Subject: Revised Remedial Investigation Work Plan – Addendum No. 1  
Y Pay Mor Drycleaners Site  
Federal Way, Washington  
King County Parcel No. 2423200050  
VCP Number: NW3265  
File No. 4082-039-03

This letter documents revised proposed supplemental explorations for the Site remedial investigation (RI) as an addendum to the “Remedial Investigation Work Plan, Federal Way Link Extension Parcel FL358, Y Pay Mor Drycleaner Site, 2210 South 320<sup>th</sup> Street, Federal Way, Washington” dated December 22, 2021 (RI Work Plan) and associated Sampling and Analysis Plan (SAP) and Quality Assurance Project Plan (QAPP). The Site is identified in Washington State Department of Ecology (Ecology) databases as Facility Site Identification (FSID) No. 2518, and Cleanup Site Identification (CSID) No. 3180. The Y Pay Mor Site is located on King County Parcel No. 2423200050, identified by Sound Transit as Federal Way Link Extension (FWLE) Parcel FL358. The boundary of the former Y Pay Mor Drycleaner (Space A-6) is shown on Figures 1 and 2. The Y Pay Mor Site is defined by the extent of chlorinated volatile organic compounds (CVOCs) in soil and groundwater exceeding Model Toxics Control Act (MT

Figure 3

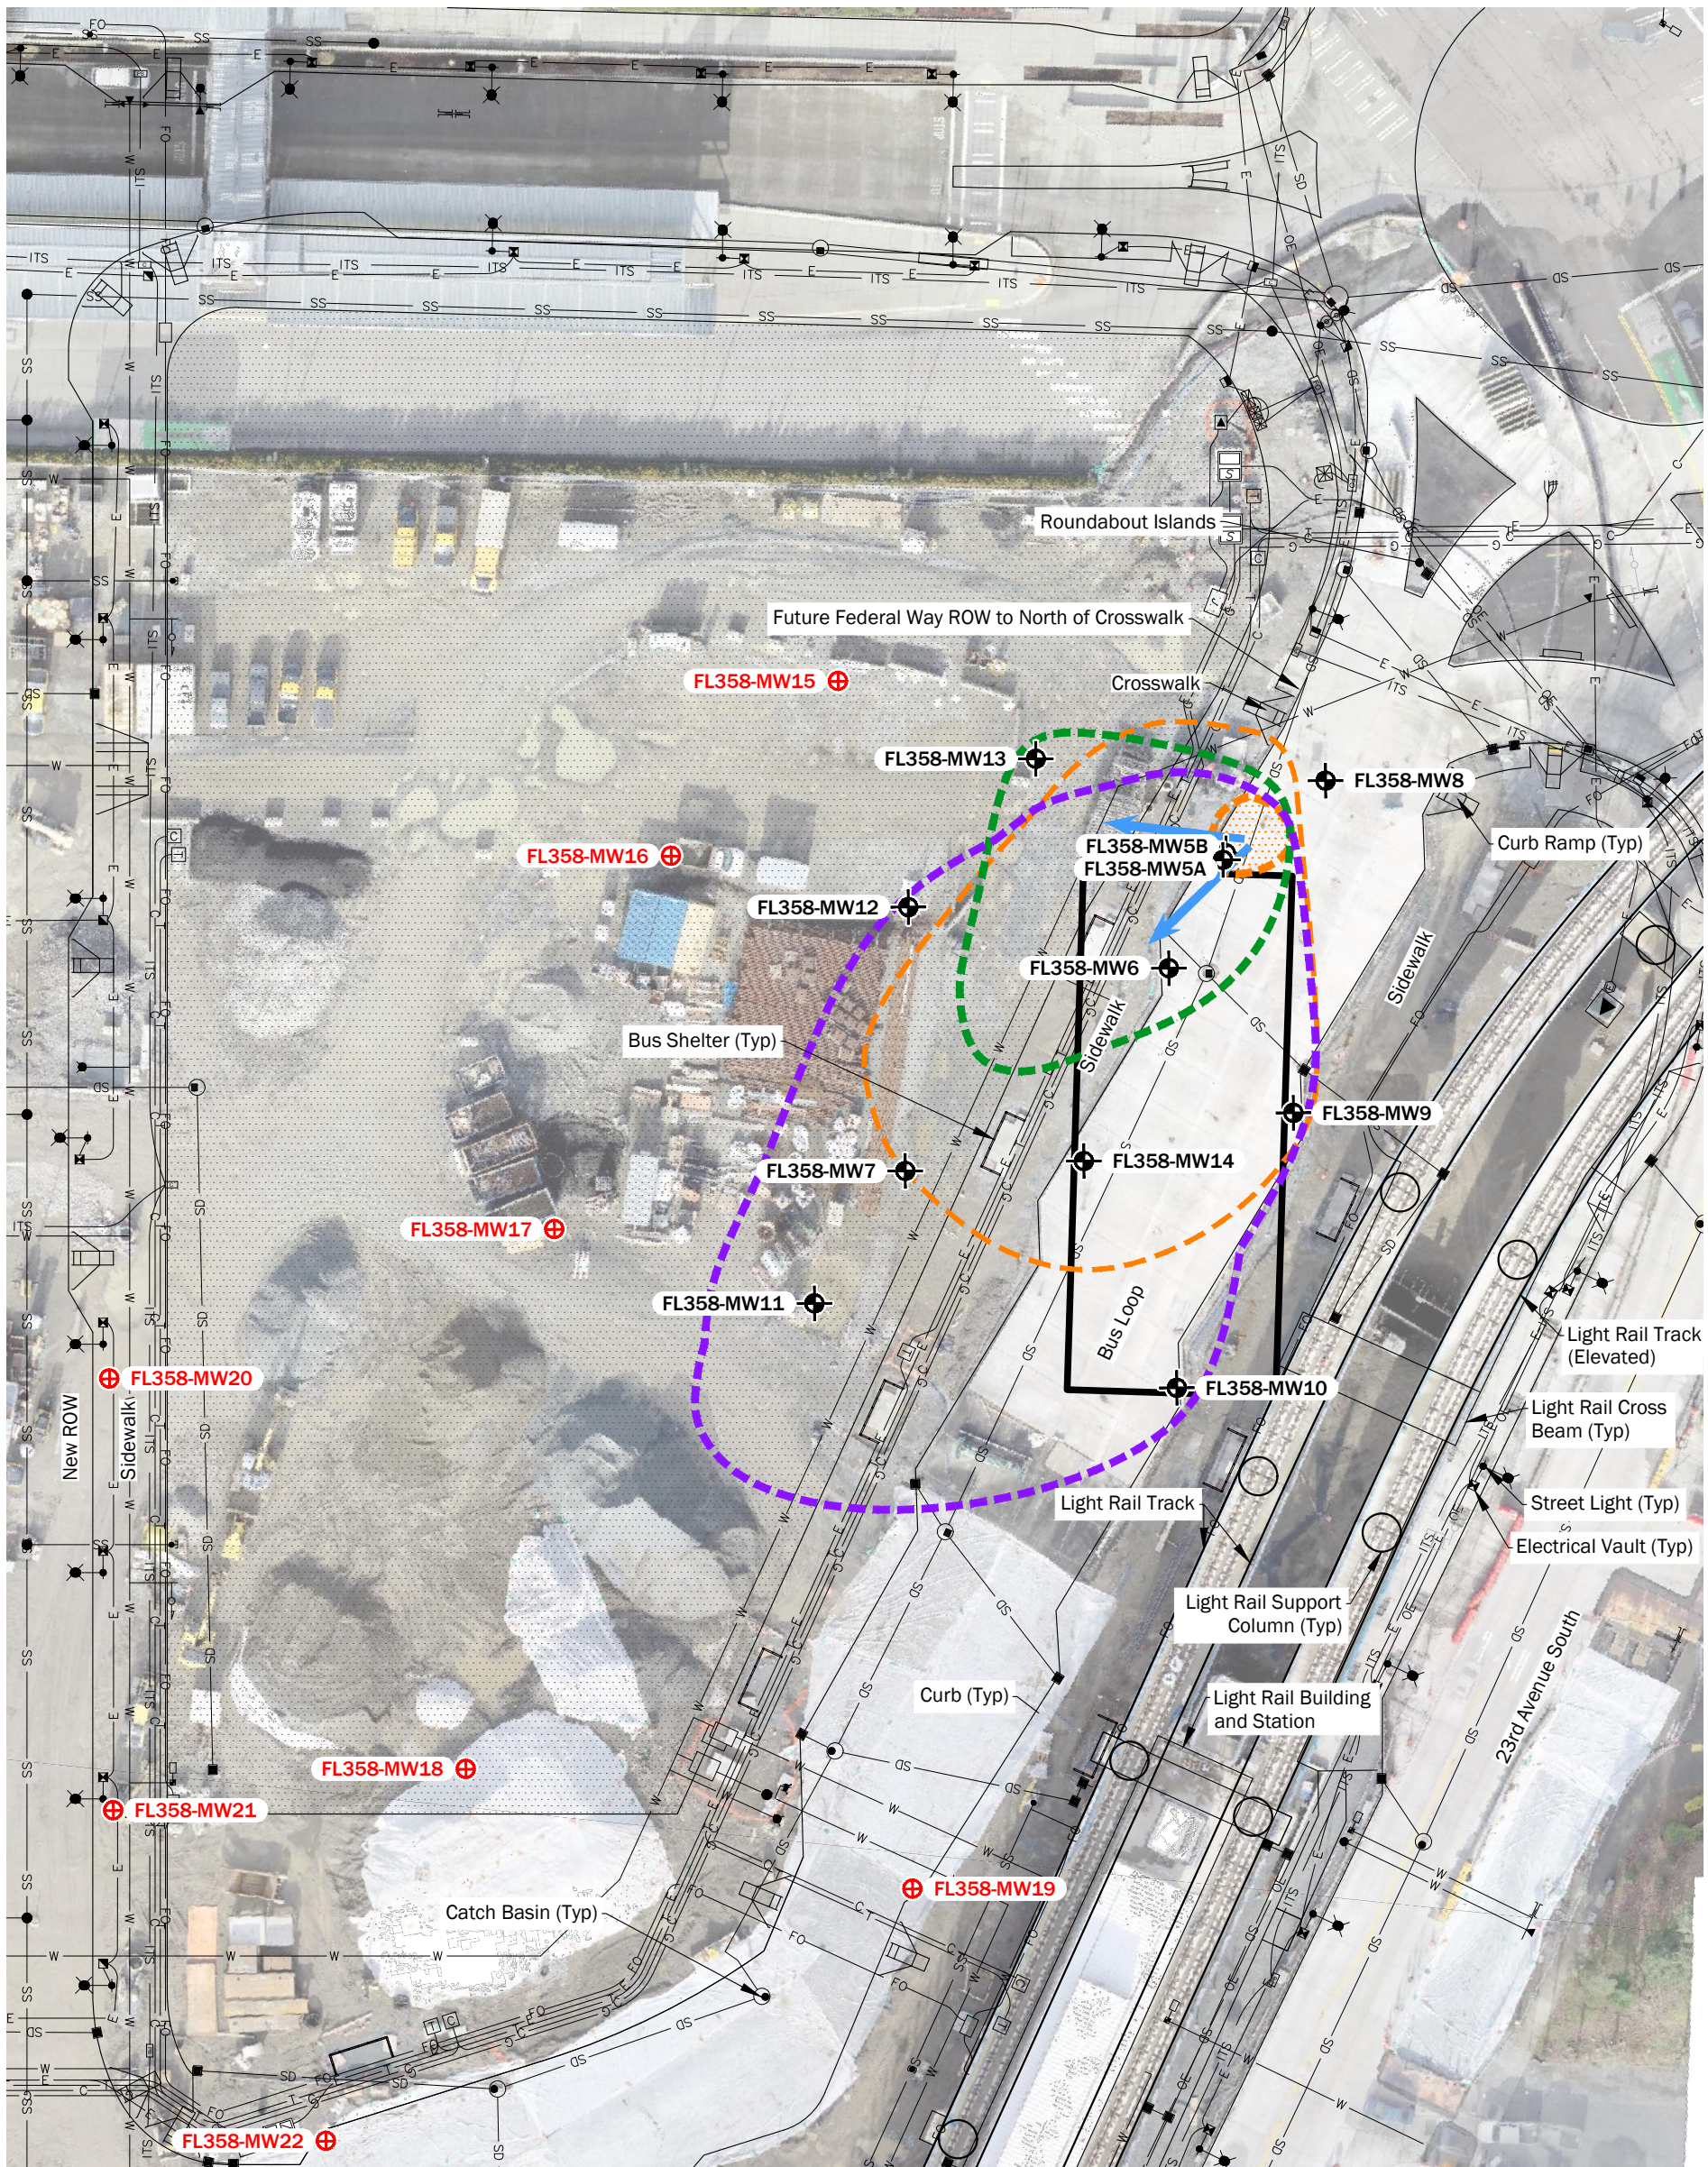
A total of eight new permanent monitoring wells (FL358-MW15 to FL358-MW22) will be installed west, south, northwest and southwest of the Y Pay Mor groundwater contaminant plume. The proposed wells, the purpose of each well, and the planned exploration boring soil sample analyses are presented in Tables 1 and 2. The locations of the proposed new wells are shown on Figures 2 and 3. Each boring will be extended to a depth corresponding to the top of the confining silt layer. The wells are planned to be installed with the bottom of the well screen positioned at the top of the confining silt layer.
